State of California
Department of Public Works
Division of Highways
Materials and Research Department

Your File No. W.O. AD05-003-C
Our No. 62286-S

FRESNO STATE COLLEGE
SPEECH DRAMA AUDITORIUM
NOISE REDUCTION SURVEY

Figure 1

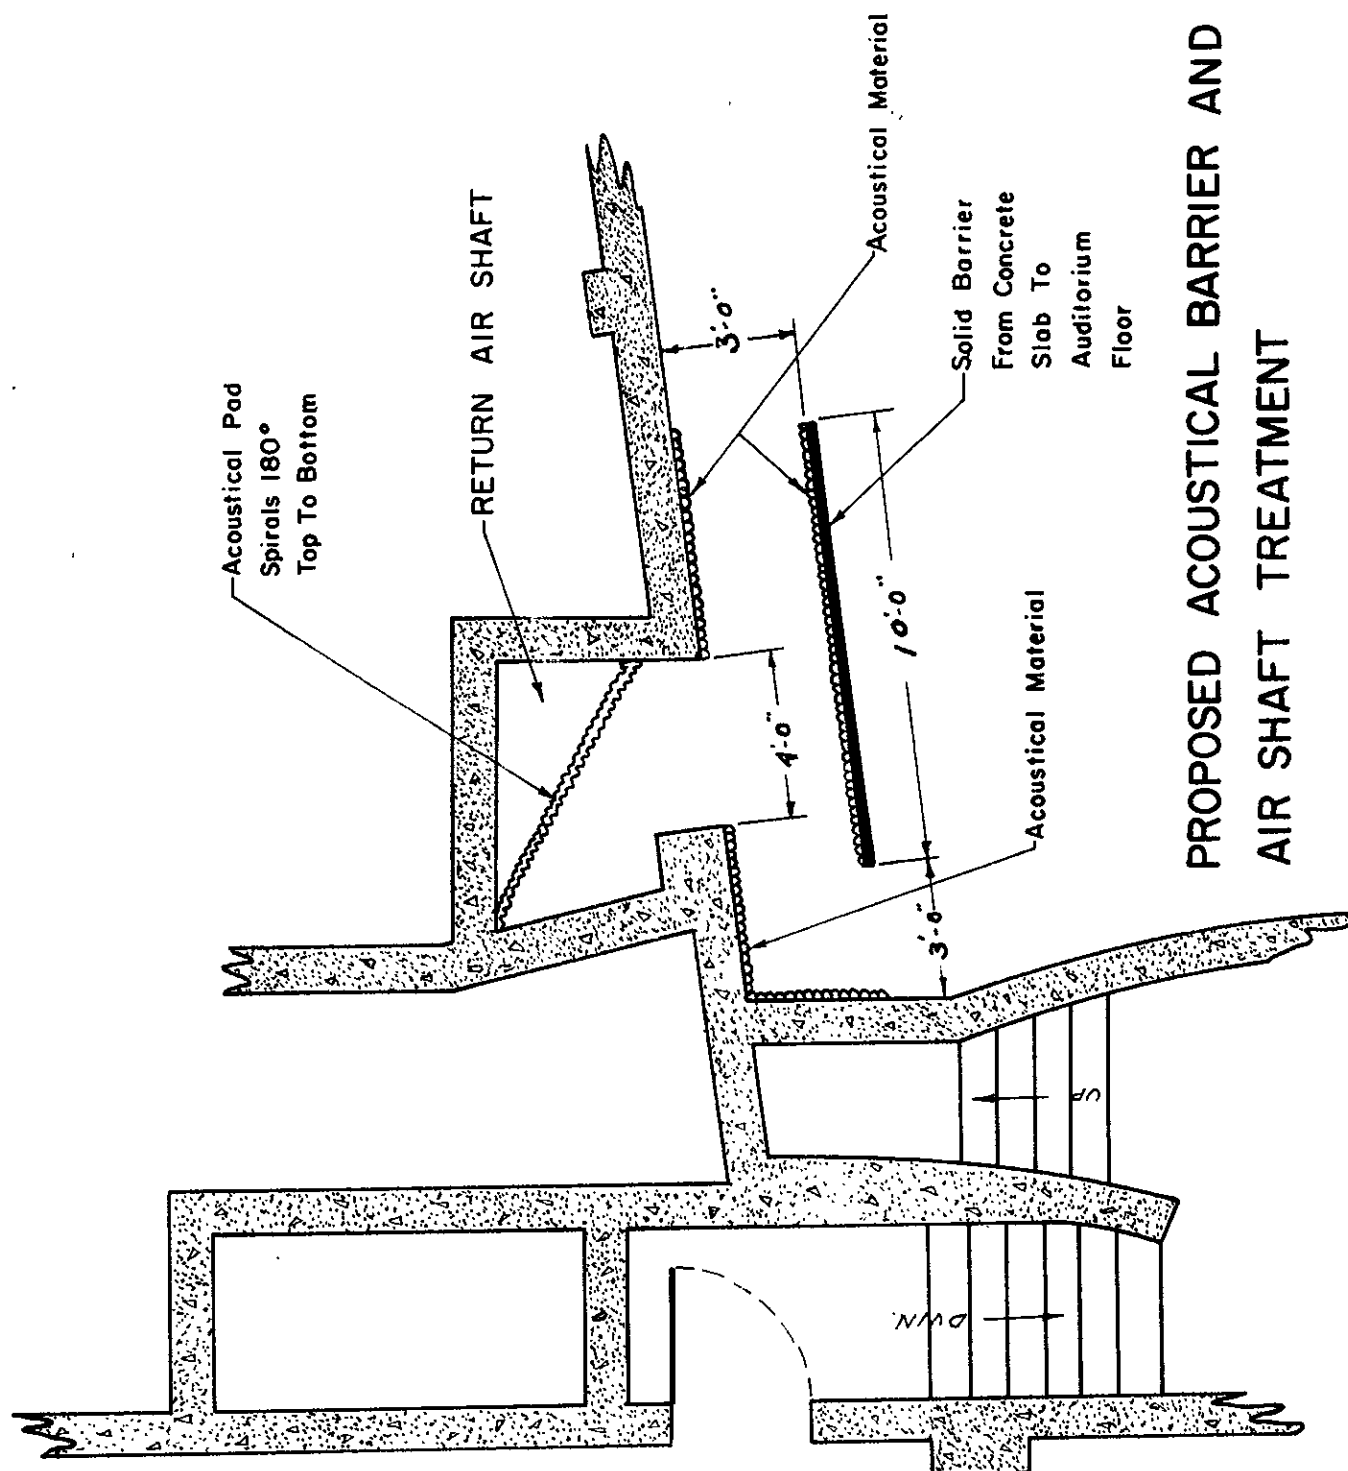
1. The three air vents located in the roof, directly over the stage, should be equipped with sound traps to reduce the penetration of aircraft noise.
2. (A) The vertical return air shaft (which runs from under the auditorium floor to Fan and Mechanical Room 206) should have an acoustical pad installed in the manner of a slow spiral, with a 180 degree turn from top (just below fan opening) to bottom (just above the port opening below the auditorium floor). The pad should begin diagonally across the longest horizontal dimension of the shaft (corner to corner) and be securely attached to the walls as it descends.

(B) A 10 foot long solid barrier should be placed 3 feet away from the lower port opening, between auditorium floor and the concrete slab. The barrier surface facing the port, and the adjacent wall surfaces, should be covered with a one inch thickness of glass fiber duct-liner or an equally absorbent acoustical material of your choice. Please refer to Figure #1.

Figure 2

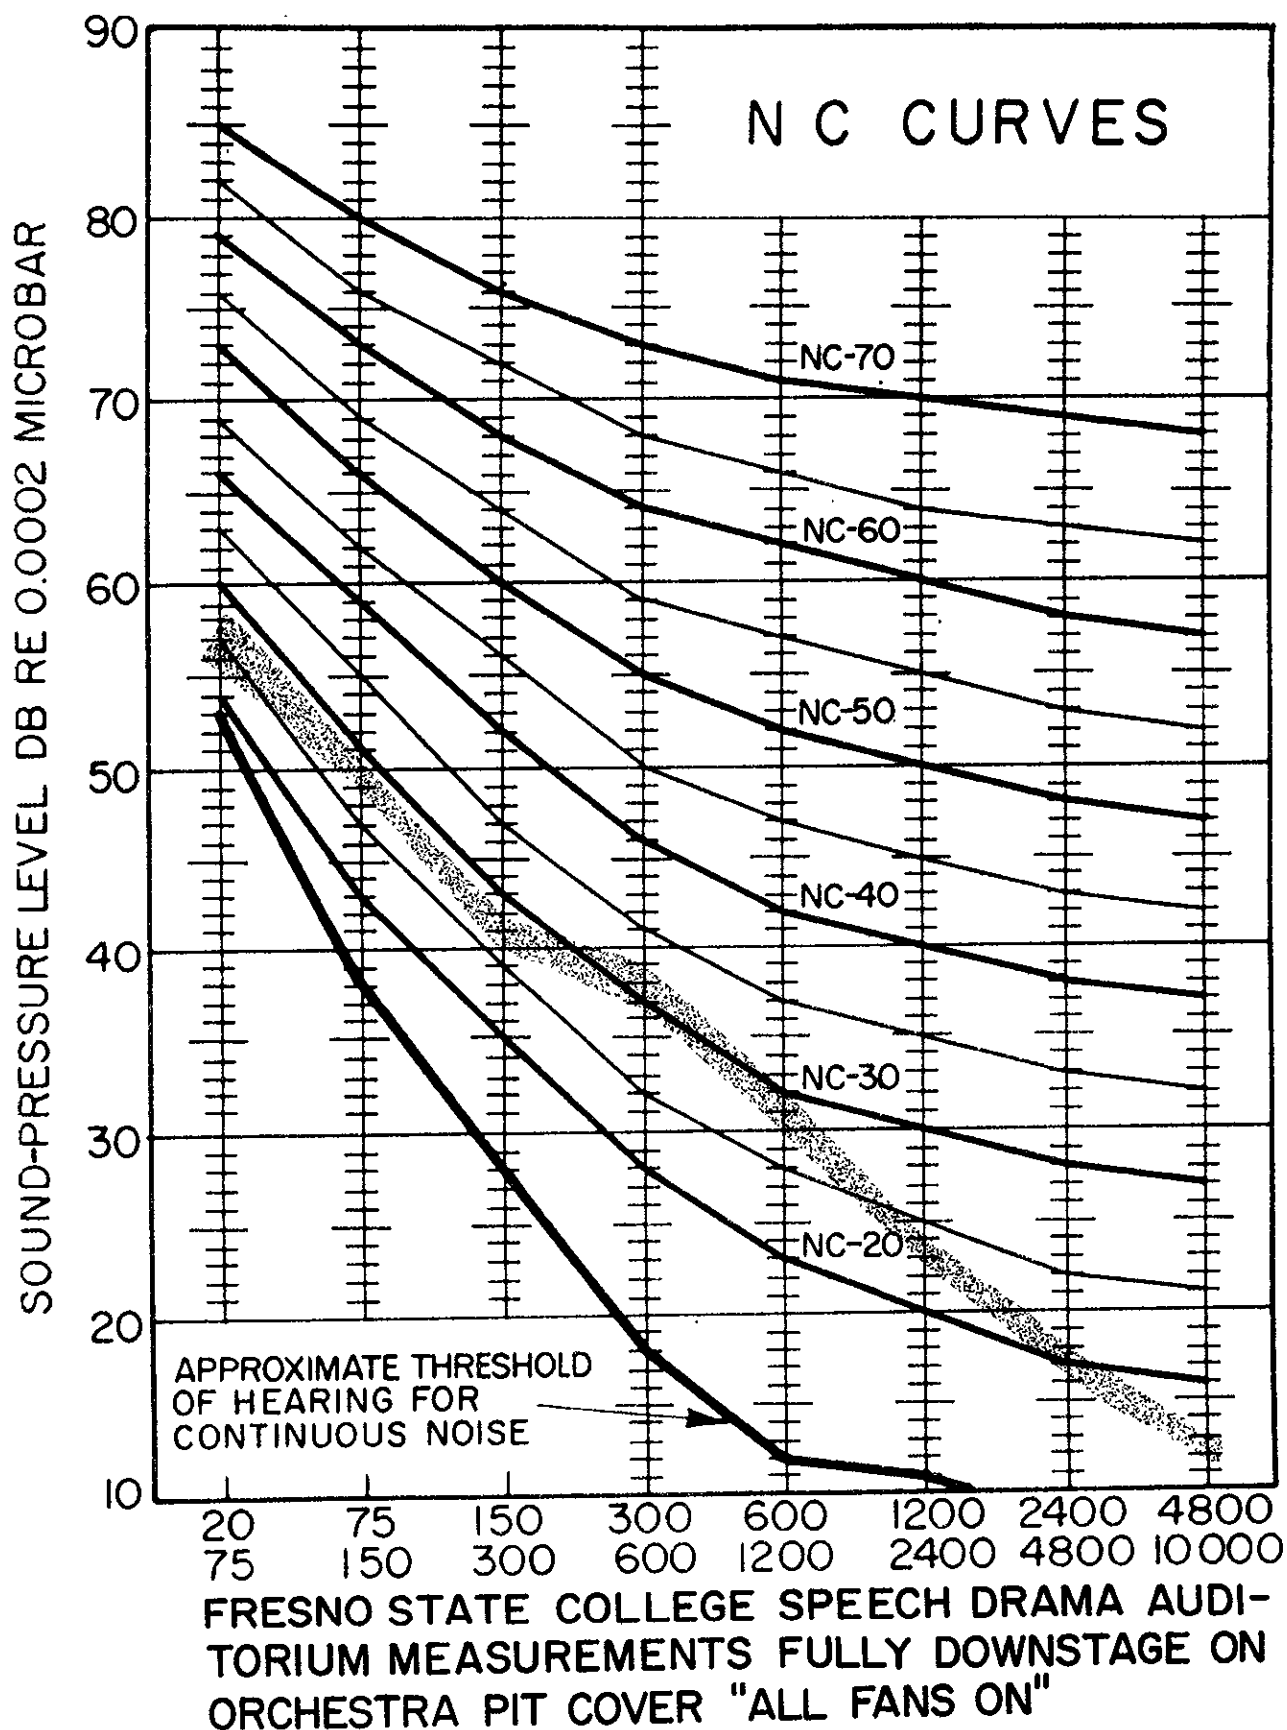
The principal internal noise source was determined to be from exhaust fan E-1. Figure 2 is an octave band portrayal of total equipment noise on an NC chart.

Figure 3

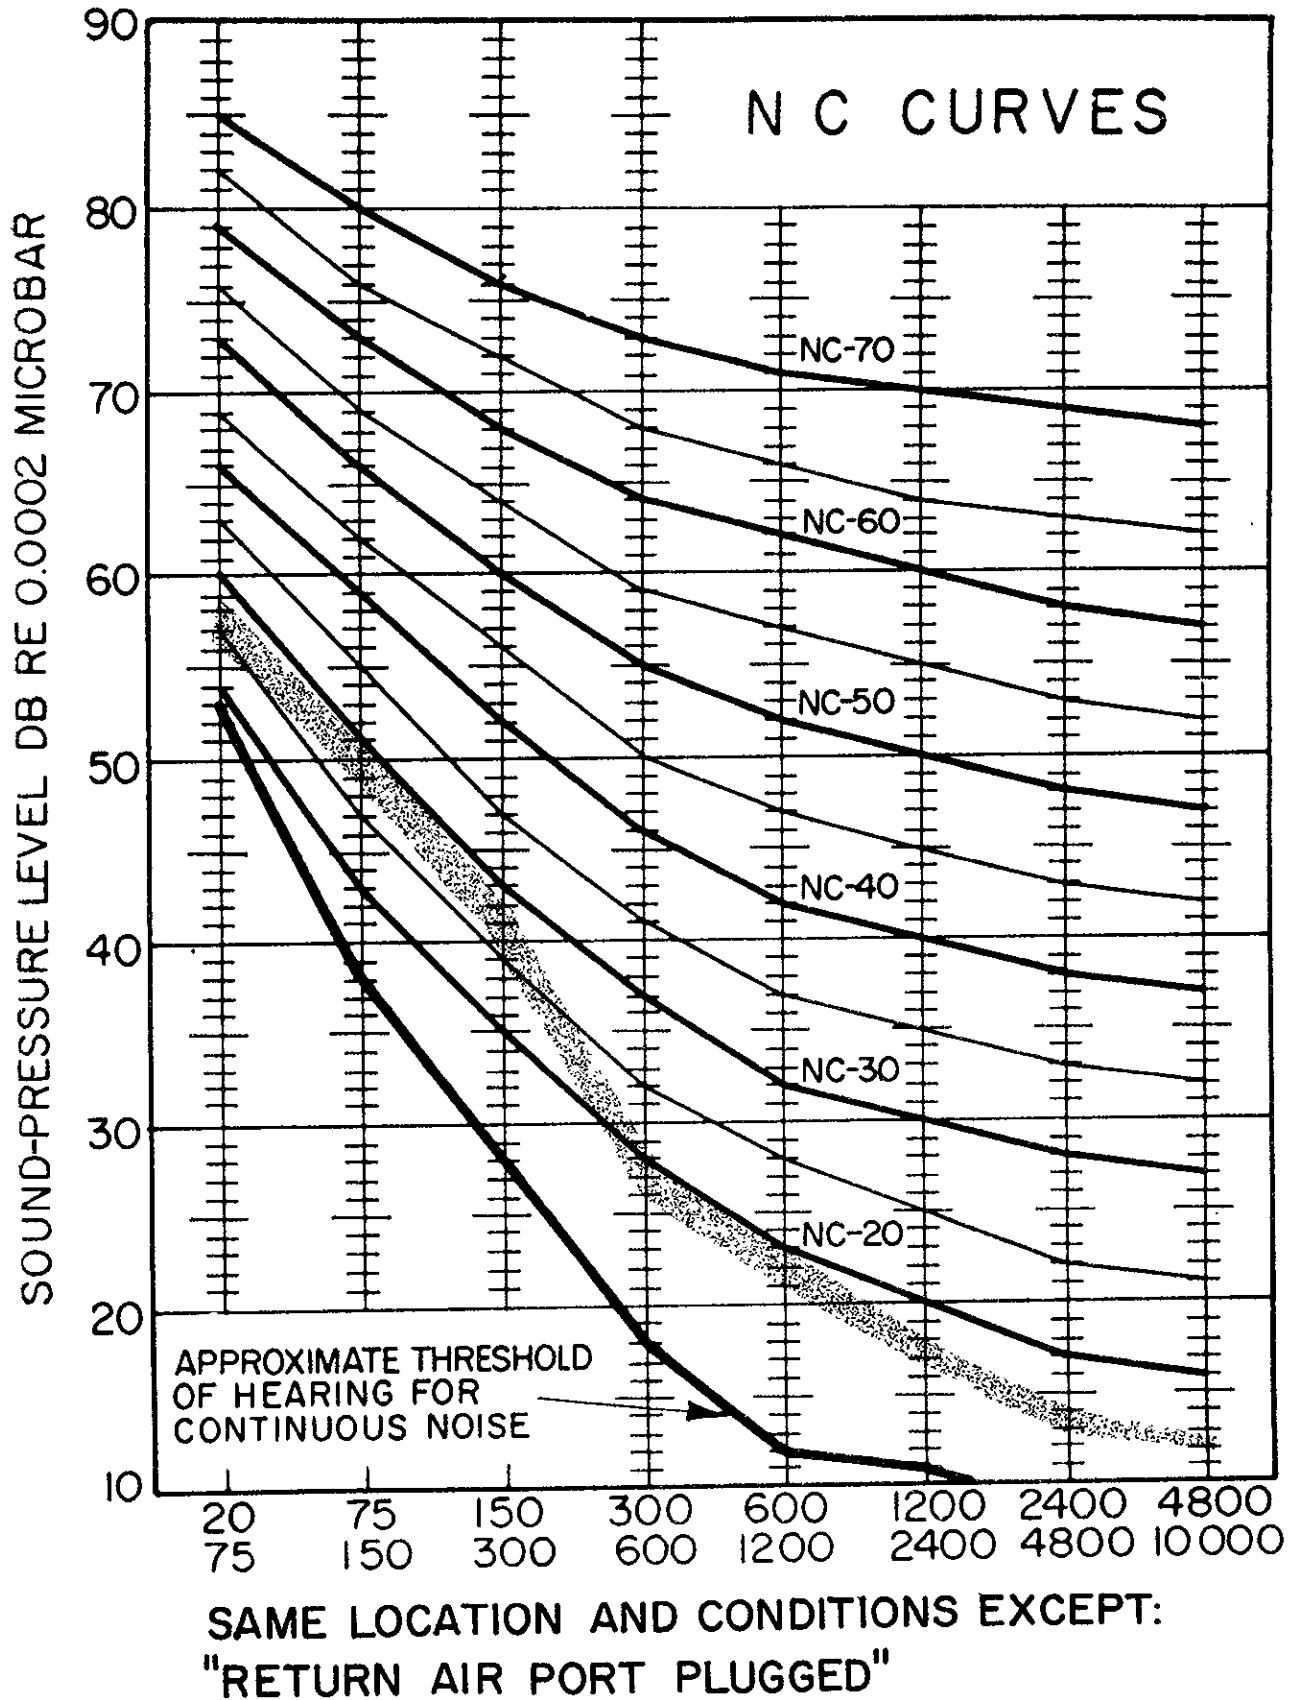
Figure 3 shows a marked noise reduction in the speech interference range, octaves 4, 5, and 6, achieved by temporarily plugging the return air port with a heavy plywood cover. This is a reasonable approximation of what can be accomplished by absorptive treatment in the shaft plus the acoustic barrier already described.
